FINAL PLAT

IRONHORSE AT OXFORD ADDITION

RE: SUB 2002-109 -- One-Step Final Plat of Ironhorse at Oxford Addition

CASE NUMBER: SUB 2002-109 -- IRONHORSE AT OXFORD ADDITION

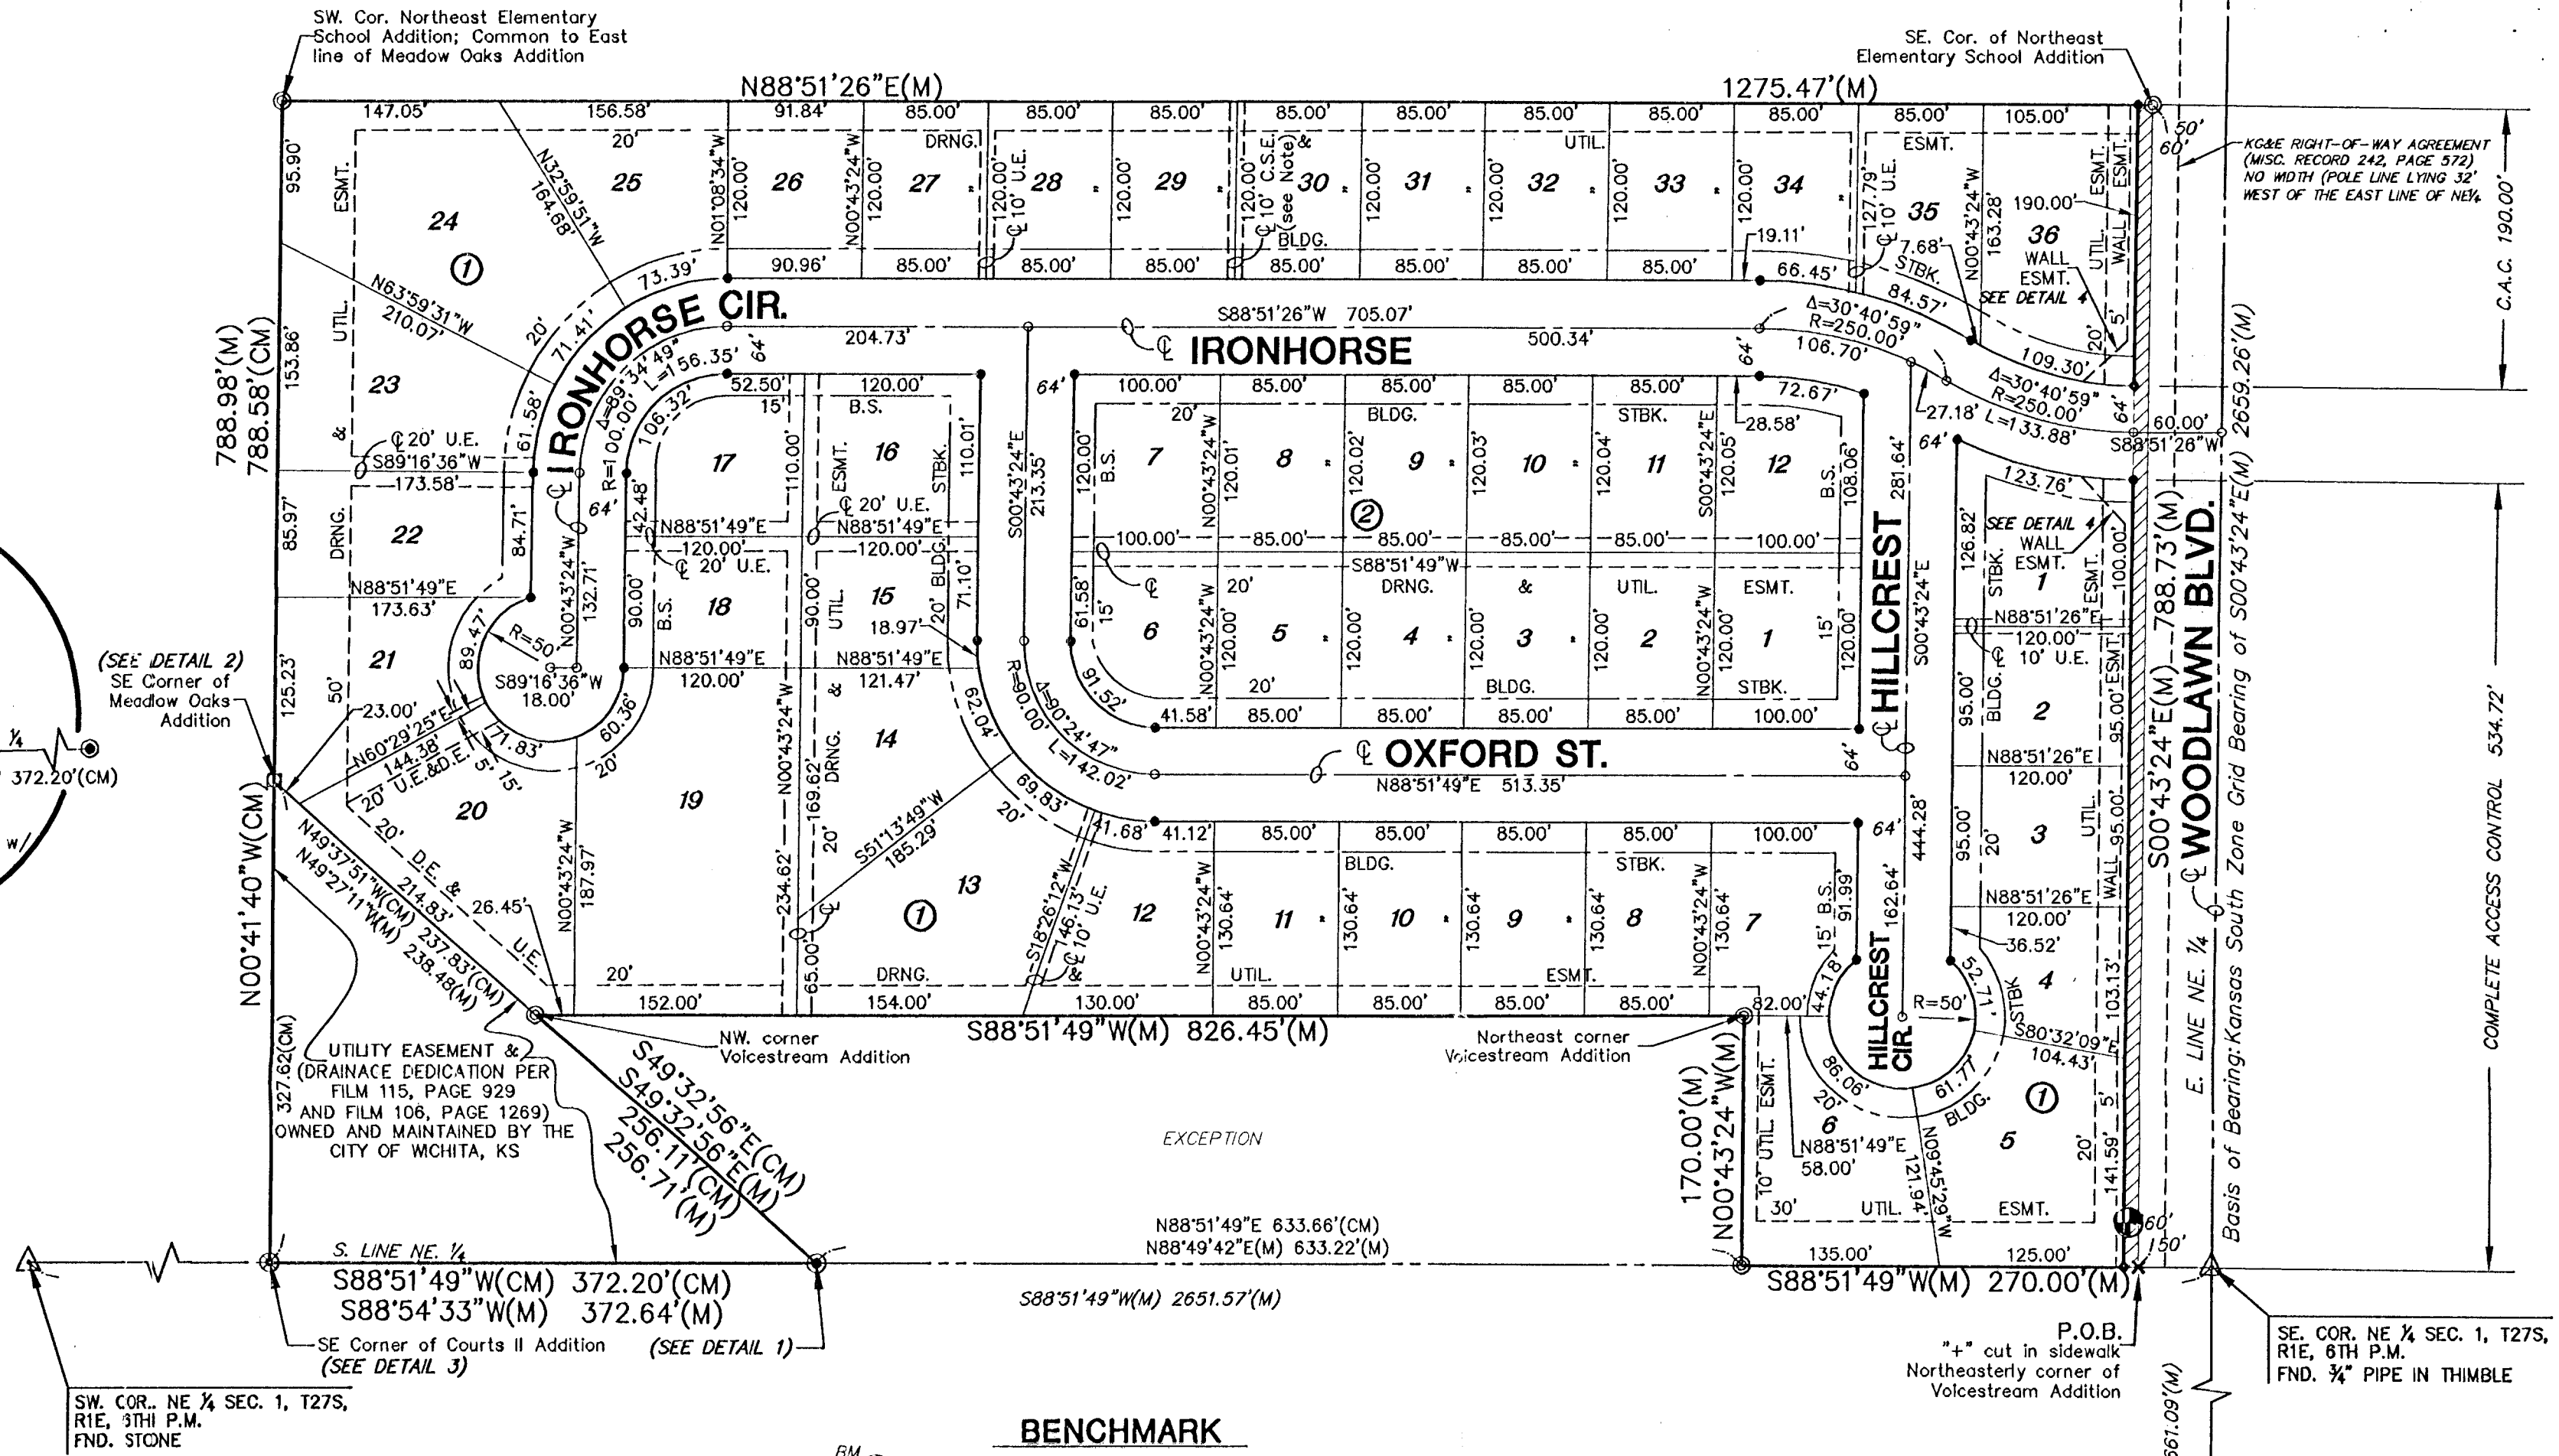
- E. The use of Reserve A for utilities located within platted easements should be referenced in the plat's text.
- F. Traffic Engineering has requested that the street opening for Ironhorse be relocated southward to be in alignment with the opening across Woodlawn.

- G. MAPD recommends a pedestrian access connection extending to the school property to the north. **The site plan for the school property shall be reviewed prior to the MAPC meeting to determine compatibility with a pedestrian connection through a platted reserve.**

- I. **Traffic Engineering** has requested the dedication of additional right-of-way along Woodlawn to conform with the 60-ft half-street right-of-way required by the Access Management Policy.

- L. The wall easement shall be referenced in the plat's text.
- M. The Applicant has platted 20-ft building setbacks which represents an adjustment of the Zoning Code standard of 25 feet for the TF-3, Two-Family District. The Subdivision Regulations permit the setback provisions to be modified by the plat upon the approval of the Planning Commission.

- N. The **City Fire Department/GIS** needs to comment on the plat's street names. *The street names are approved.*
- O. The sewer easements (Film 145, Page 104) and (Film 45, Page 116) need to be located.

- P. The centerline of Ironhorse needs to be located along Woodlawn.
- Q. The Applicant is reminded that a platting binder is required with the final plat. Approval of this plat will be subject to submittal of this binder and any relevant conditions found by such a review.

A contingent sidewalk easement shall be platted extending to the school property to the north. The easement shall become effective upon extension of the sidewalk northward through the school property. Expiration of this contingent sidewalk shall occur two (2) years after the recording date of this plat.
